**DOCUMENT - 2025-366T
HELIPORT RETROFIT IMPLEMENTATION AT 13653 MCLAUGHLIN ROAD,
CHELTENHAM, PEEL REGIONAL POLICE FACILITY
ADDENDUM 2**

Referring to the above Document 2025-366T - Heliport Retrofit Implementation at 13653 McLaughlin Road, Cheltenham, Peel Regional Police Facility, please note the following:

DRAFTER:	RJC	SCALE:	AS NOTED
DESIGNER:	RVG	DATE:	2025/02/21
APPROVER:	LC	CHECKER:	RVG
PROJECT No:	Z0022639	DRAWING No:	E-502
SHEET No:	10 of 11

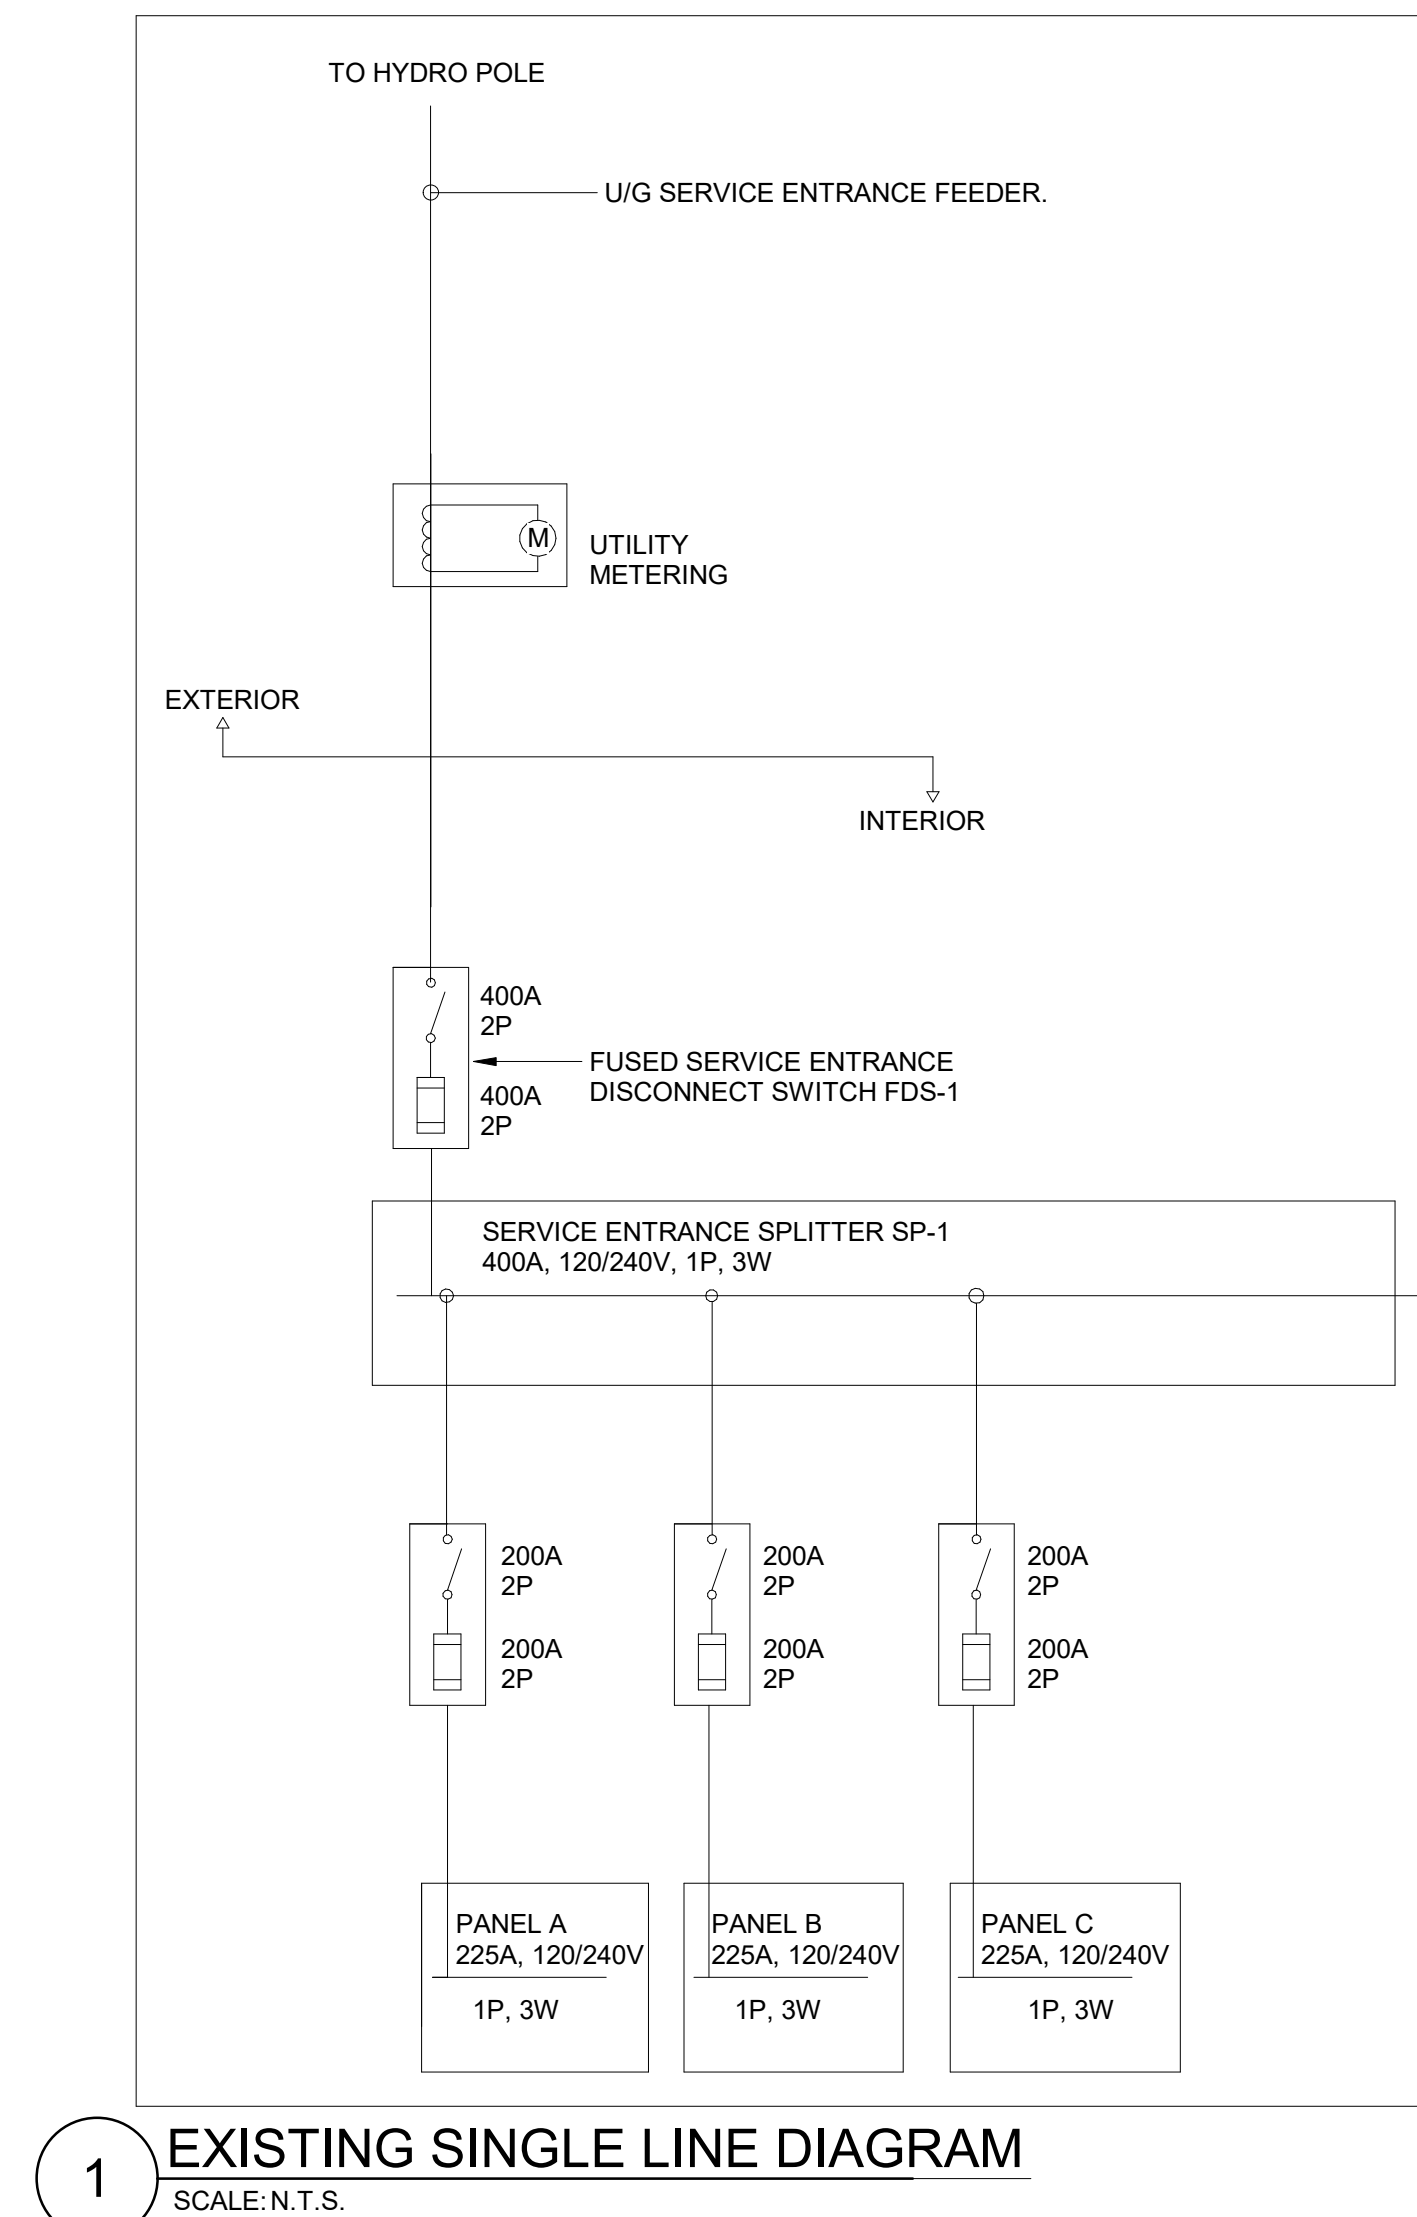
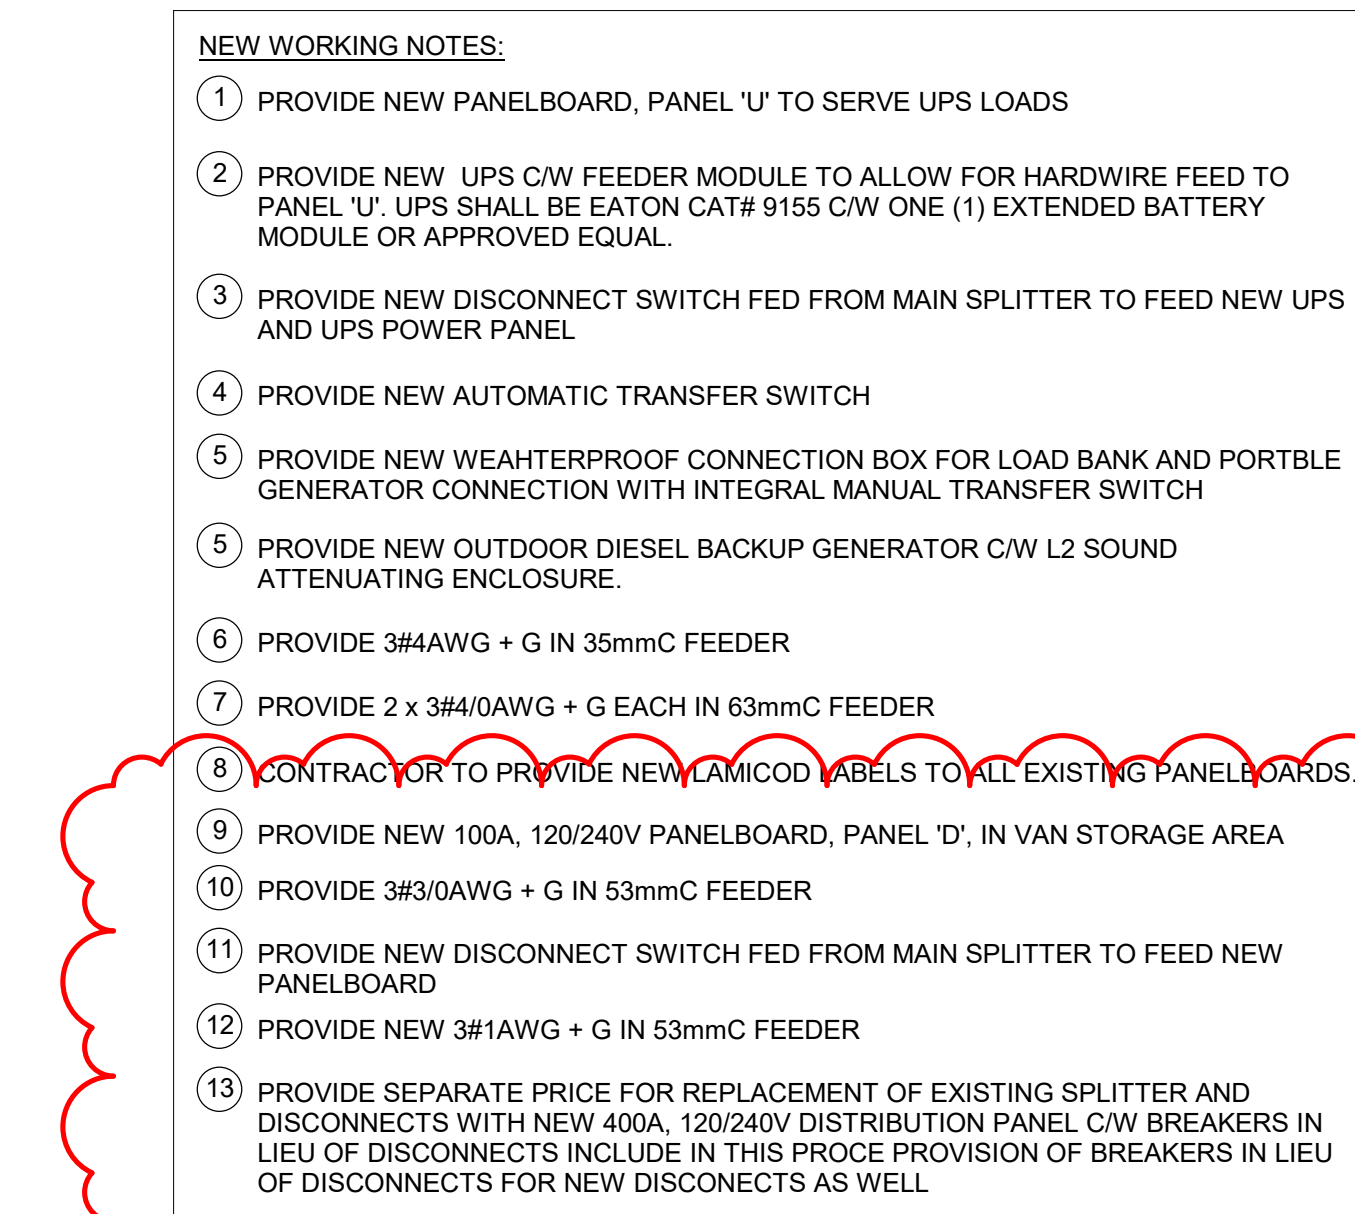
Drawing E-502 (see attached drawing for details)

New drawing issued

- Added panel schedule for new panelboard Panel 'D'

DISCIPLINE:	ELECTRICAL
DRAFTER:	RJC
DESIGNER:	RVG
APPROVER:	LC
PROJECT No:	Z0022639
SHEET No:	9 of 11
SCALE:	AS NOTED
DATE:	2025/02/21
CHECKER:	RVG
DRAWING No:	ES101

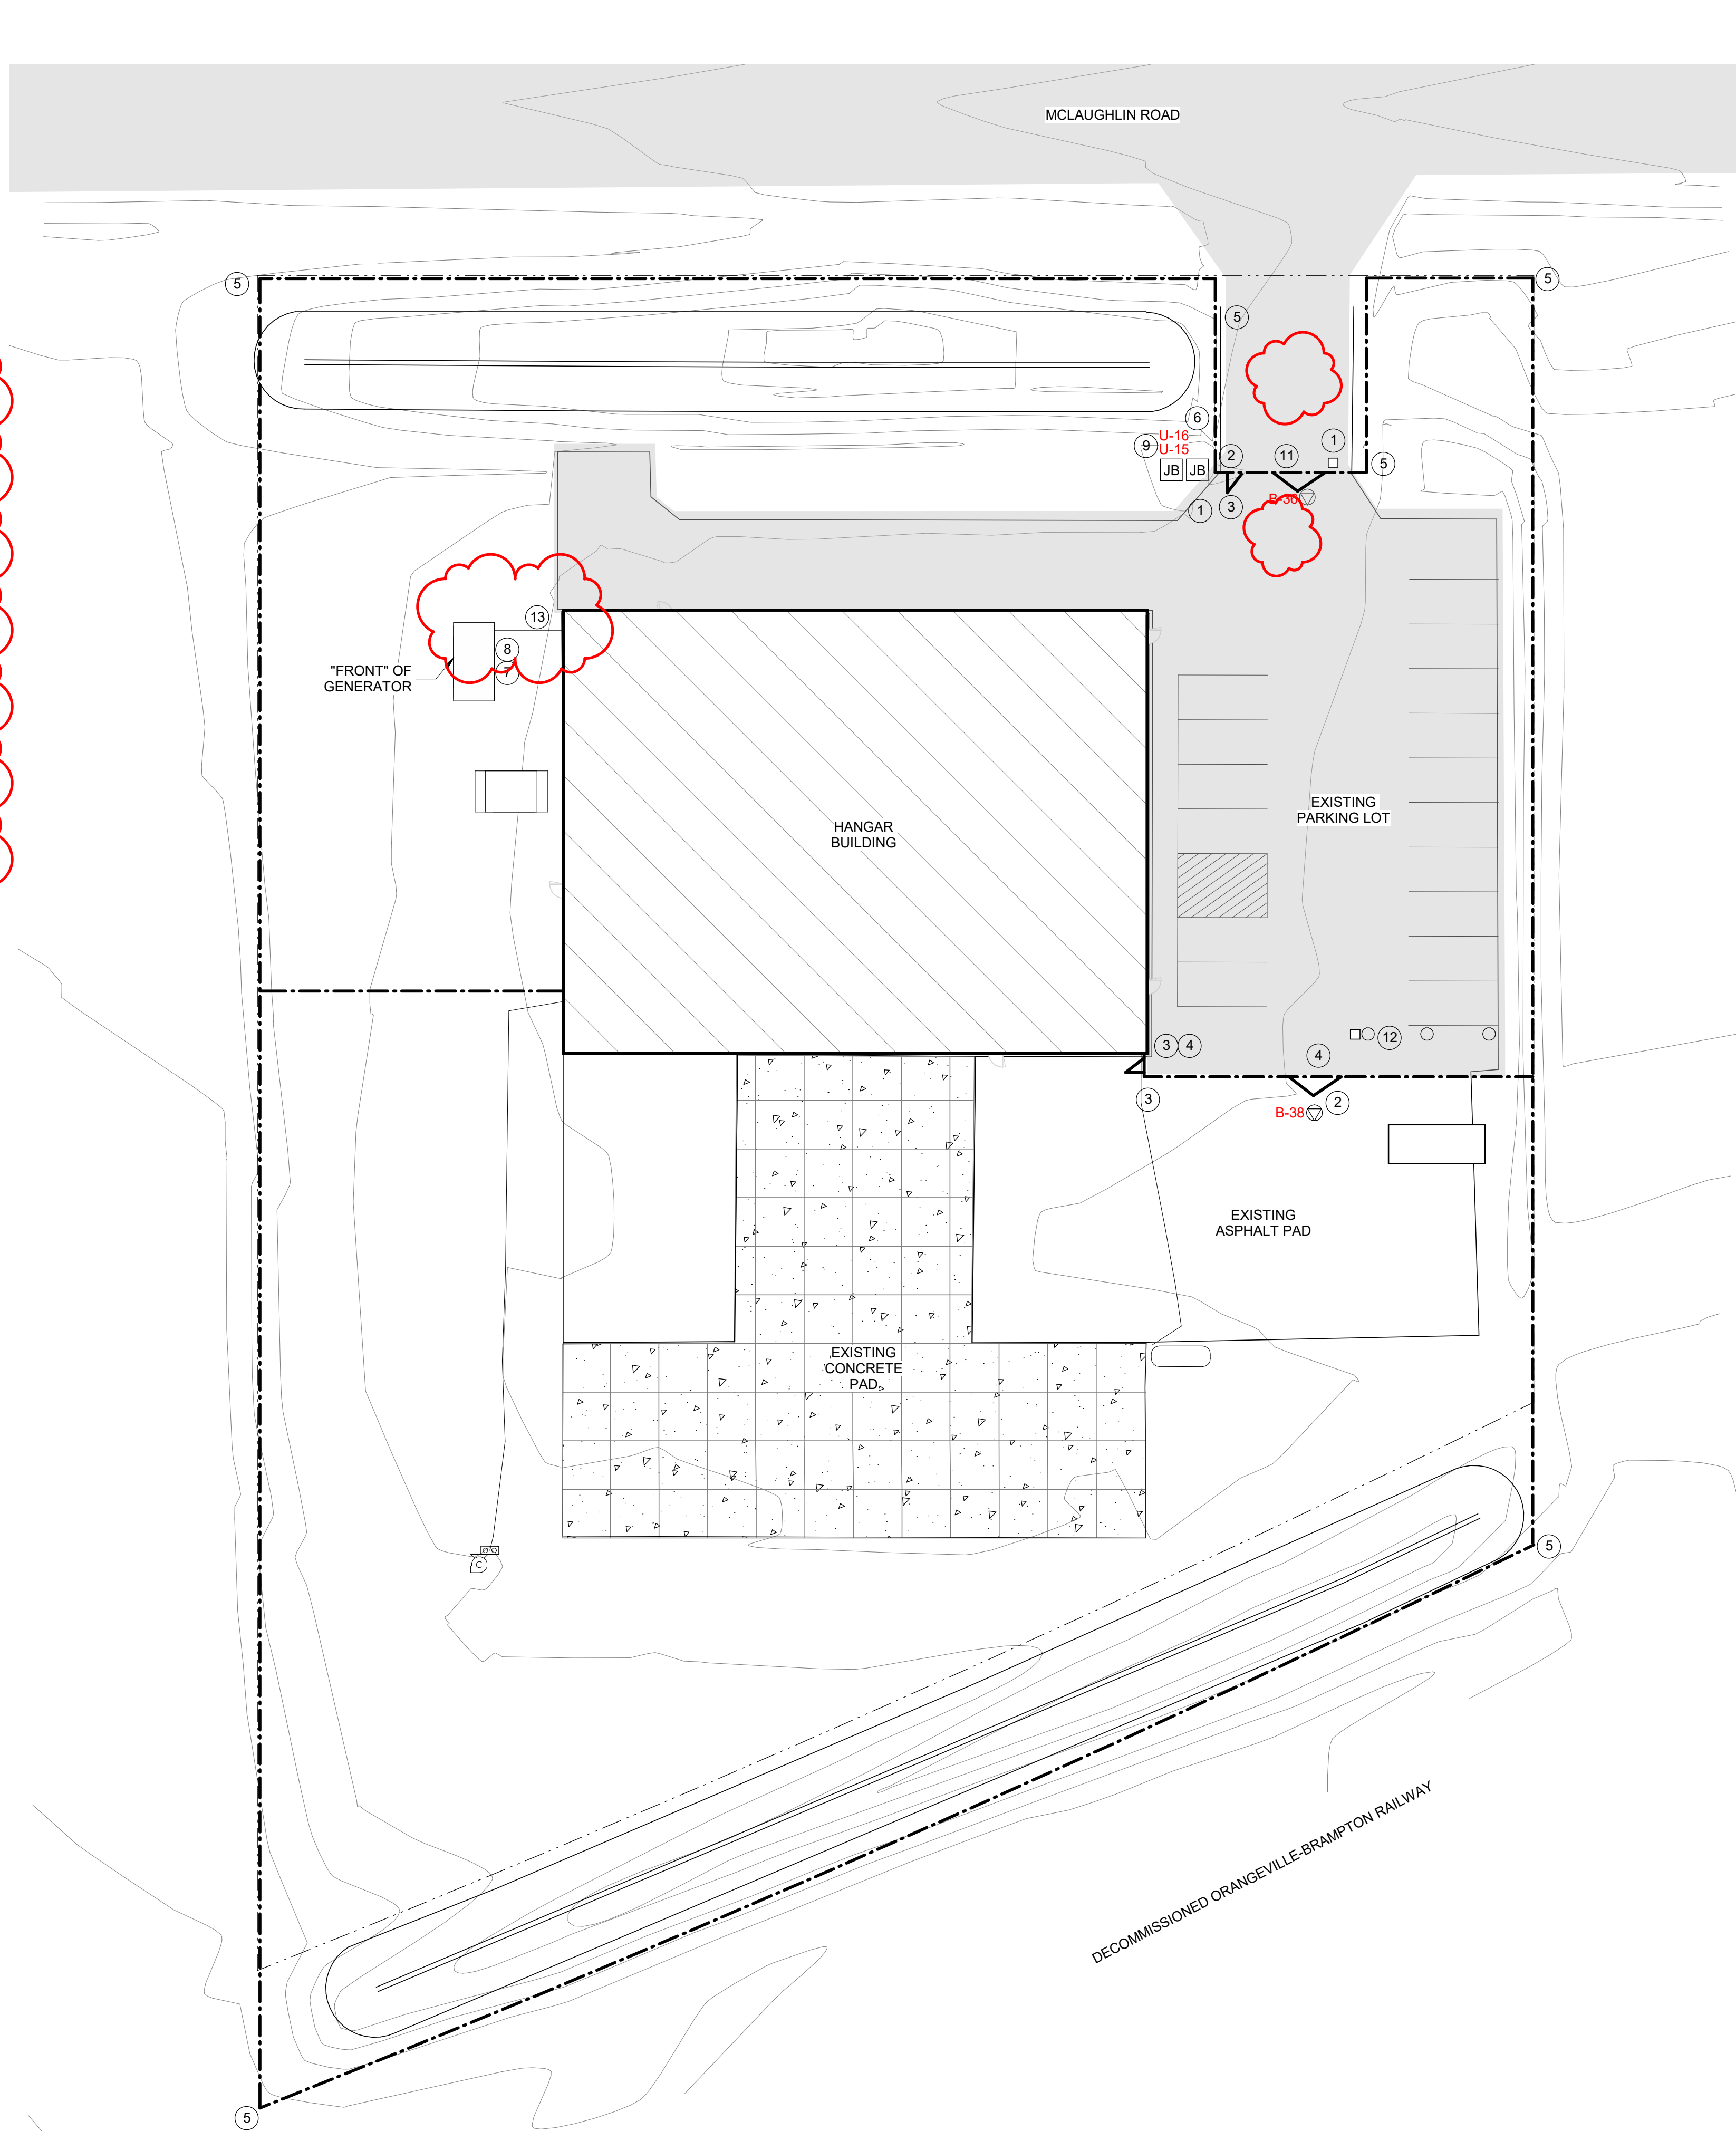
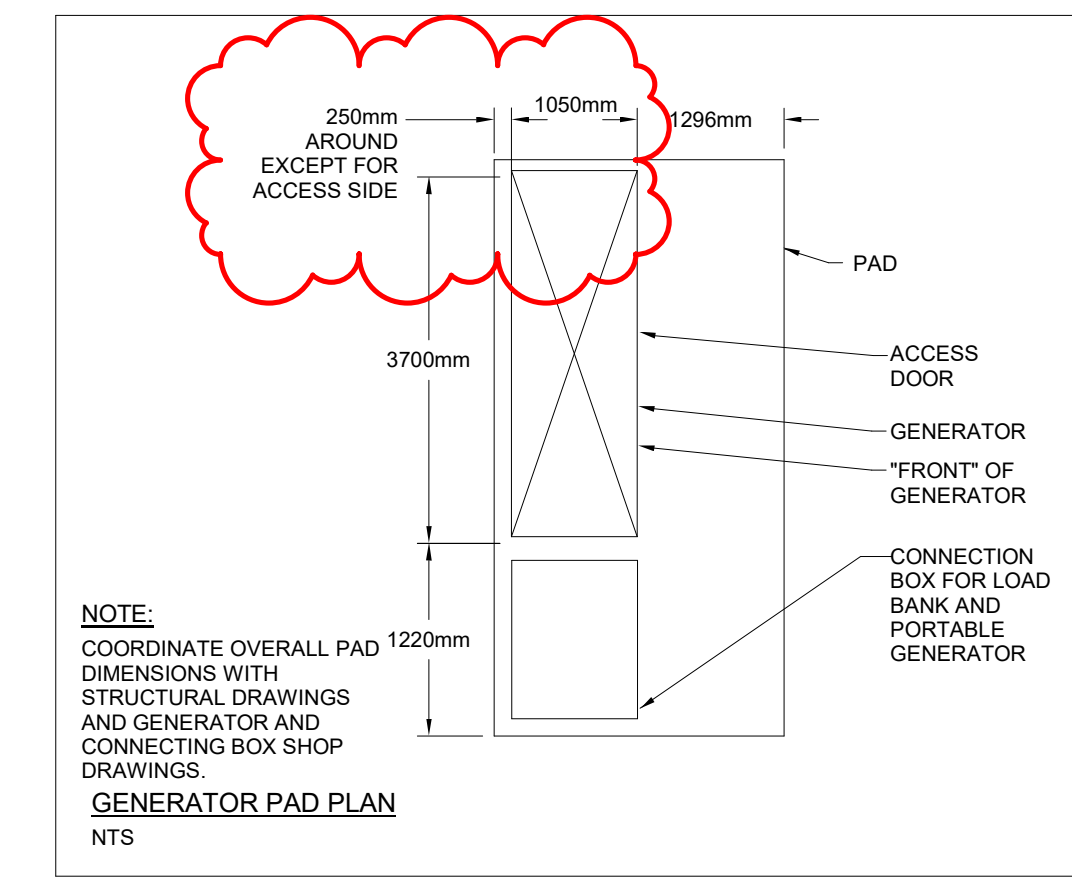
- Updated single line diagram to show new distribution for new Panel 'D'
- Drawing ES101 (see attached drawing for details)
- Deleted working note #11 as per previous addendum
- Clarified conduit routing in working notes to note start and end points of conduit runs
- Added detail for buried conduits

- Revised nominal dimensions for generator concrete pad.
4. **Attachments:**
- Revised Drawing M-102 Ground Floor Plan – New & Demolition HVAC (1 – 24x36")
 - Revised Drawing M-103 Second Floor Plan – Demolition HVAC (1 – 24x36")
 - Revised Drawing M-104 Second Floor Plan – New HVAC (1 – 24x36")
 - Revised Drawing M-701 Details & Schedules (1 – 24x36")
 - Revised Drawing ES101 Electrical Site Plan (1 – 24x36")
 - Revised Drawing E-101 Ground Floor – Power Layout (1 – 24x36")
 - Revised Drawing E-103 Second Floor – Power Layout (1 – 24x36")
 - New Drawing E-502 Panel Schedules II (1 – 24x36")
 - Revised Drawing E-601 Single Line Diagram (1 – 24x36")
5. **DELETE:** Specification section 01 45 00 clause 1.2.1 in its entirety.
6. **DELETE:** Instructions to Bidders, item 11.1 in its entirety.

There is electrical civil work shown on drawing ES101 that is neither shown on drawing E101 nor identified in Table 3 of Online Bidding System (i.e. note 5 on drawing ES101 indicates to provide underground empty conduit for security cameras all around perimeter of site; similarly for notes 3, 4 ,6 on same drawing).

2. What is the size, thickness as well as concrete and reinforcing requirements for generator concrete pad (note 7 on drawing ES101).

Cash allowance for the Generator Scope of work is contradicting the Generator Scope of work shown on the Electrical Drawings, such as ES-101

Notes on the ES-101 do not make sense, because rough-ins are not specified as start and end points – and locations.

Table 4 on the Online Bidding System has been revised to include a line item for the pricing of the work referenced on drawing ES101 for all "landside" electrical work that is not otherwise addressed as a cash allowance or included in Table 3.

Details to follow in a separate addendum regarding conduit and concrete pad.

Cash allowance is to include supply of ATS, Generator, and connection box equipment supply only. Include in the base price installation and all other materials including but not limited to conduit, wiring, terminations,

Rough-in locations in the field are to be generally located where the working note is placed on the drawing, with exact locations to be coordinated on site.

The following rough-ins are to run back to the IT/Server room from the building exterior: security cameras, card readers, any other security/access control devices.

Working note #6 rough-ins to be run to the closest accessible area within the building and marked as spare for future use.
